**REPLIES TO PRE BID QUERIES LOT-3 Dated 19.01.2026  
COAL GASIFICATION PLANT FOR GENERATING SYNTHETIC NATURAL GAS (SNG) AT BARDHAMAN**

CLIENT :	CGIL (JV OF GAIL AND CIL)	REV.	1/1/2025
LOCATION :	INDIA	SHEET	1 OF 1
TITLE :	PRELIMINARY LAYOUT OF COAL BASED SNG PLANT CAPACITY : 80,000 NM3/hr. SNG	SCALE :-	1 : 2500
		DRG. No.:-	PC217-0000-0001
		FILE :-	PC217-0000-0001_REV P3
		DRG. SIZE:	A0

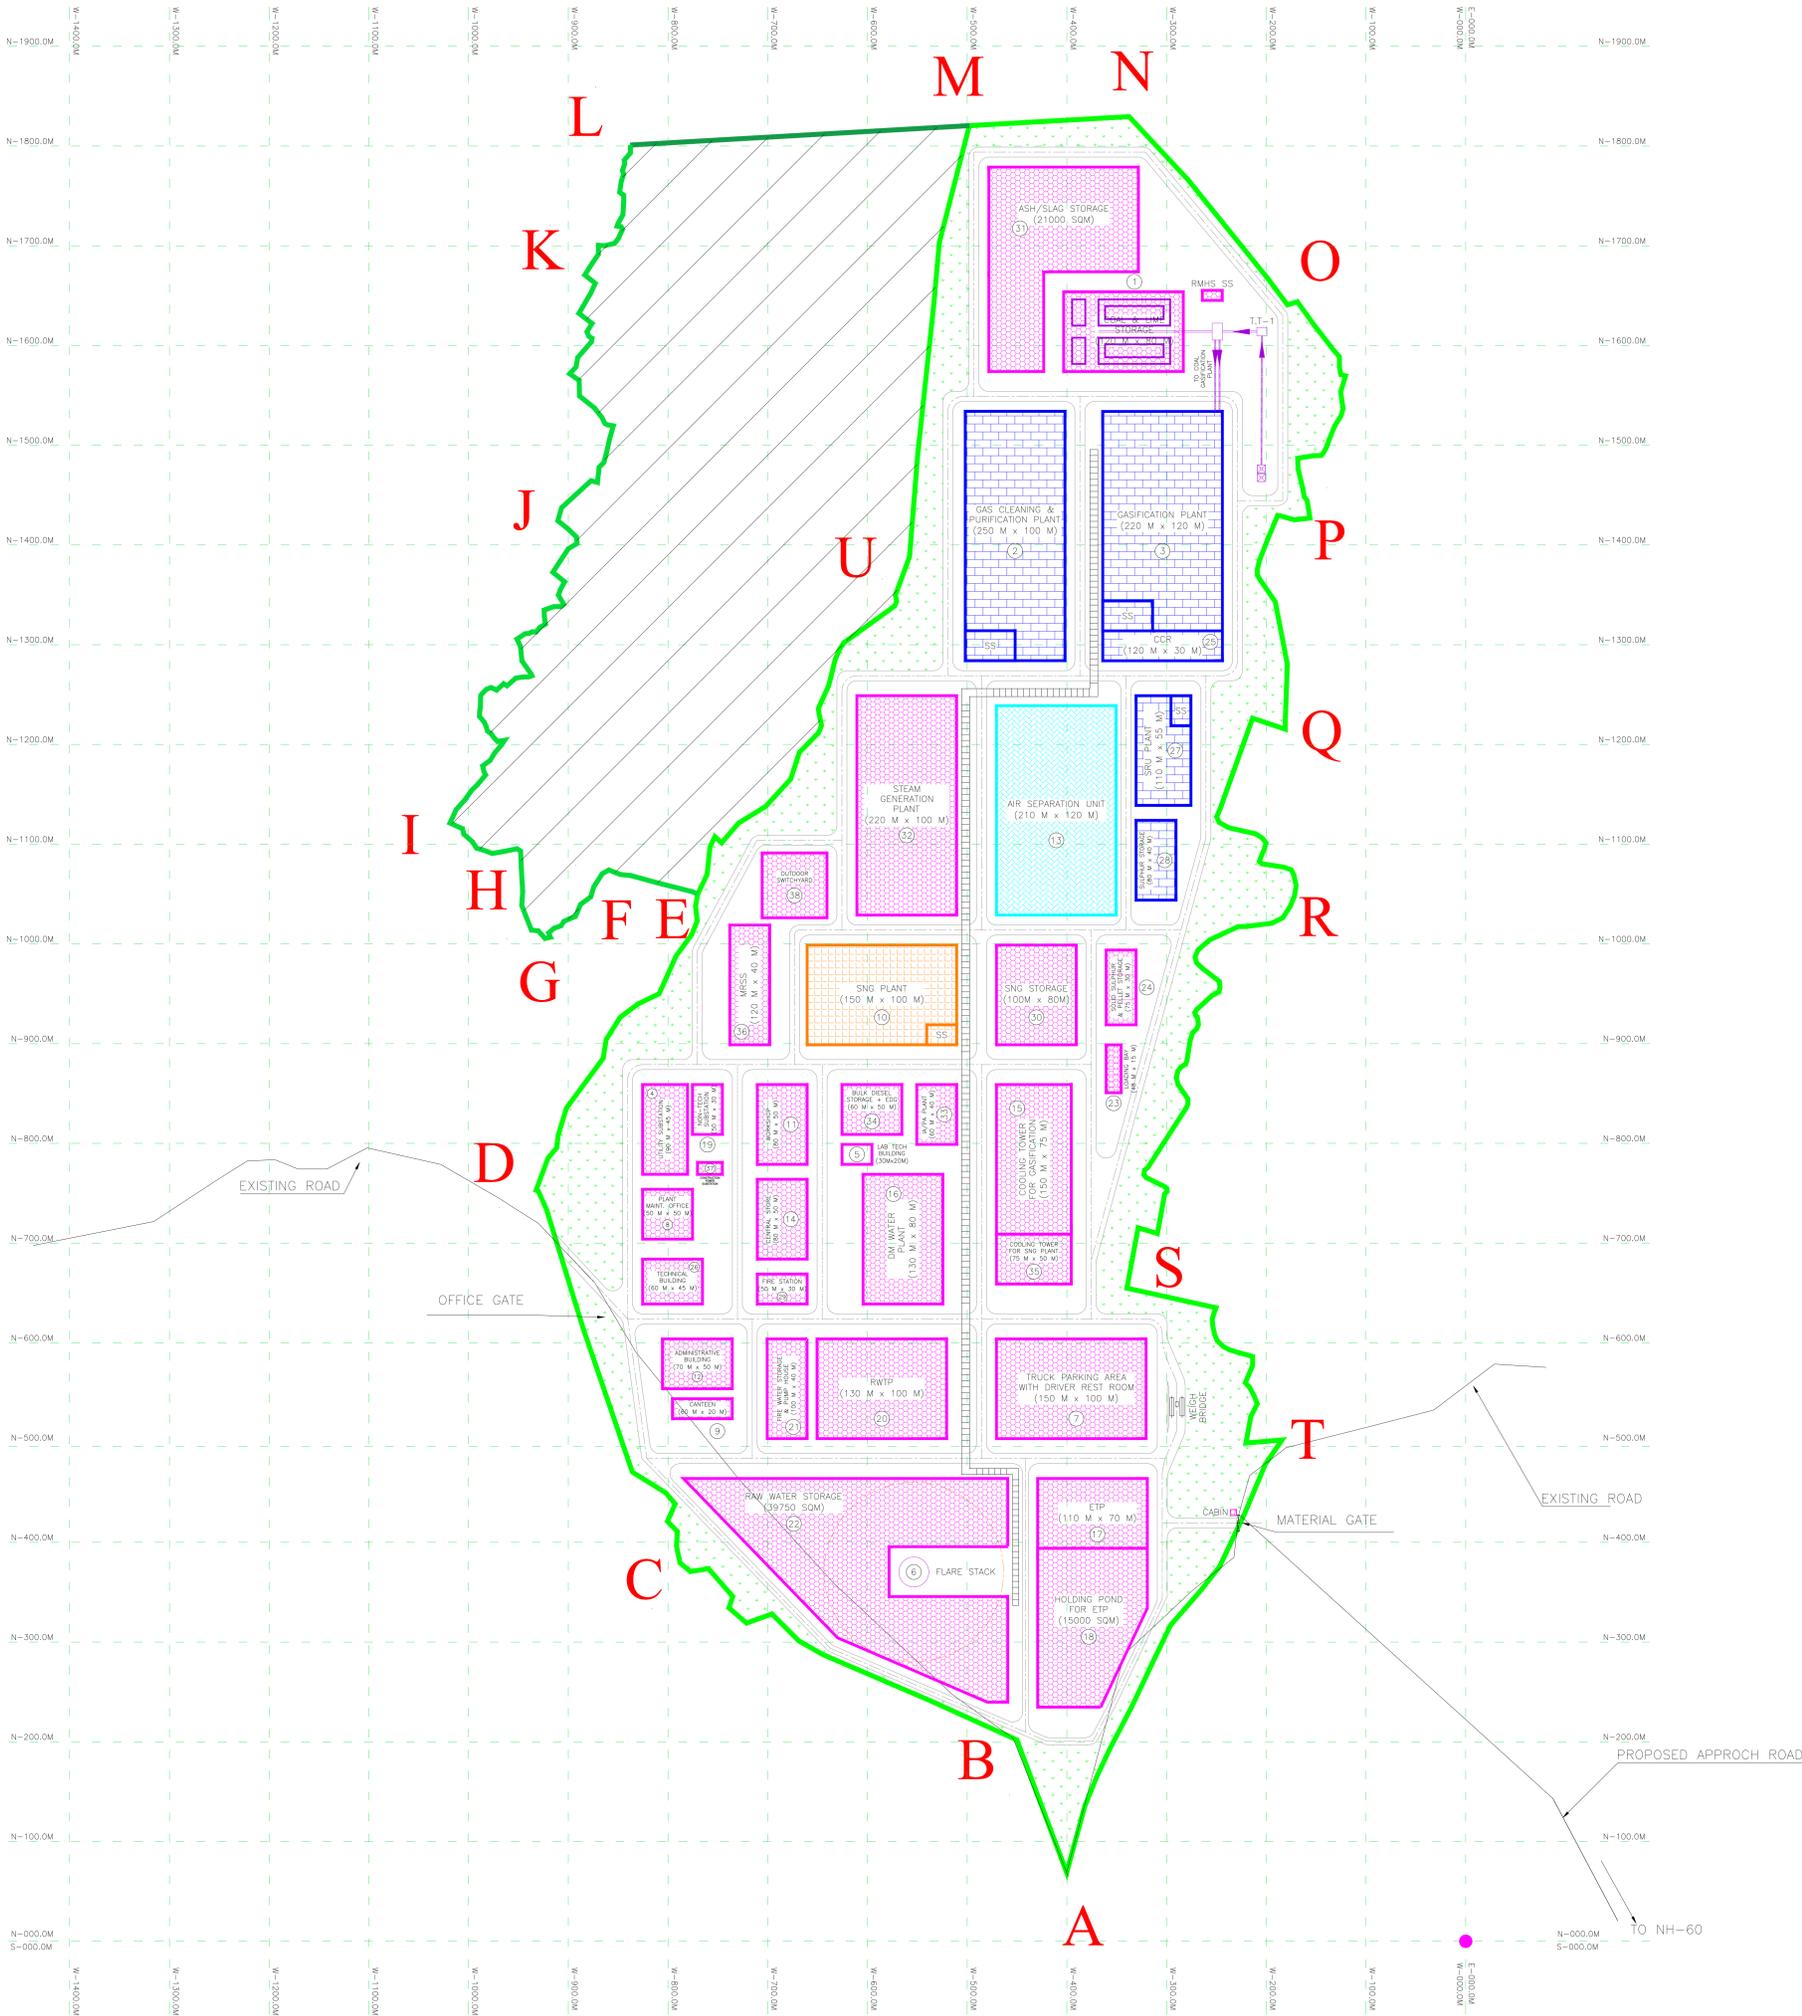
SL NO	NIT PART	SECTION	PAGE NO	CLAUSE NO	NIT SPECIFICATION	Queries	Final PDIL/OWNER Reply
4	PART-II, TECHNICAL	PC217/E/001/P-II/SEC-1.0 PROJECT DESCRIPTION	4 of 9	1.0	Based on the shortlisted licensor(s) for coal gasification, bids will be invited for executing the project on LSTK basis. The Detailed Feasibility Report (DFR) will be finalized based on the price of the lowest LSTK bidder. Subsequently, a decision will be made to place the order with the lowest Lump Sum Turnkey (LSTK) bidder for the execution of the project.	The shortlisted technology licensors are offering different coal gasification technologies. Kindly clarify the basis of evaluation, how technical and commercial disparities among the offered technologies will be normalized or compared during bid evaluation	Please refer Clause 32 of Instruction to Bidders
11	PART-II, TECHNICAL	PC217/E/001/P-II/SEC-3.0 CONTRACTOR'S SCOPE OF WORK	4 of 7	1.3	Non-Plant Buildings	Who is authorized to define / categorize plant and Non-plant buildings.? Are non-plant buildings identified in NIT Layout?	noted and refer the plot plan

52	PC217/E/001/P-II/SEC-2.0 Sheet 3 OF 9 PC217/E/4001/P-II/ SEC-4.1 Sheet 3 of 6	Raw Material, Product and Utility & Utility Specifications Batter limit Interfaces			Product Specifications and Battery Limits	Please provide Battery limit locations indicated on Layout drawings covering Battery limits for Coal, Fluxant, Oxygen, HP/MP/LP steam, Cooling water, LP/HP Nitrogen, Instrument Air, Demineralised water, Service water, Process water/Raw water, Drinking Water, Plant Air supply, Fire Water, LDO, Pre Treated Condensate, Power supply etc.	Bidder to indicate the location of the Utilities/Product/Feed at the battery limit of LSTK-1 based on its layout.

56	Layout drg. PC 217- 0000-0001 Rev P3				Preliminary layout of Coal based SNG plant	Request CGIL / PDIL to provide AutoCAD file of the Layout drawing.	Please refer to the attached PDF plot plan layout drawing. As AutoCAD files cannot be uploaded on the CPP Portal, the AutoCAD drawing will be provided separately to bidders upon request.
62						Area will be required for fabrication yard and storage of heavy outdoor equipment and also for the Labour colony of construction worker	same shall be discussed during detail Engineering However area for labour colony of construction worker will not be provided.
63	PART II: Technical	Corrigendum III Annexure-I Coal Analysis	Table - 1	2	Ash Content in coal analysis	<p>As per corrigendum-III, ash content is between 14.9% (after washing) ~18.4% (raw coal from mines).</p> <p>Tender specifications (Design Basis Clause 2.4 mentions Washed coal with 20% ash content&amp; performance of both PDC (plant running at 100% capacity) and EDC (plant running at 120% capacity) shall be ensured by LSTK-1 Bidder and penalty is applicable for non-performance.</p> <p>Please clarify which % ash content shall be taken for gasification design</p> <p>Do we need to consider ash content 14.9% ash for PDC &amp; 20% more for EDC.</p> <p>Delay in design of gasifier leads to delay D&amp; E in downstream equipment, process equipment, civil &amp; structural etc.</p> <p>Please clarify.</p>	<p>In line with washed coal analysis issued wide Corrigendum-III, Coal ash % Wherever "Ash Content upto 20%" is mentioned in the Tender document, shall be read as "Ash Content upto 18.4%".</p> <p>Accordingly Gasifier shall be designed for handling washed Coal with Ash Content upto 18.4% Air Dried Basis (average).</p> <p>For Guarantee Test Run Cases pls refer Section 8.0 of Tender Document considering Ash Content upto 18.4%.</p> <p>Necessary Corrigendum in this regard shall be issued.</p>
